CODE COMPLIANCE CERTIFICATE
BUILDING CONSENT NO: 80328

Description of Work: CONVERT GARAGE TO SLEEPOUT

Building Consent no: 80328
Issued by: Rotorua District Council (operating as Rotorua Lakes Council)

Building Consent Authority Inspection Summary Sheet

1 BRACING ELEMENTS
1:50

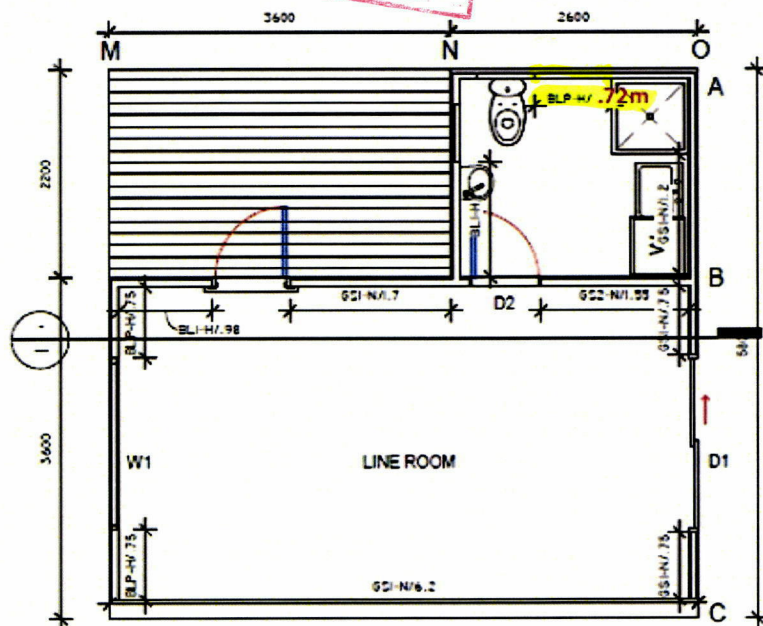
CHANGE IN BRACING LINE LENGTH ALONG SHOWER AREA.

Minor Variation Assessed
- Minor BRACING CHANGES / CALCULATIONS
& Plans Provided.

Approved
Variation
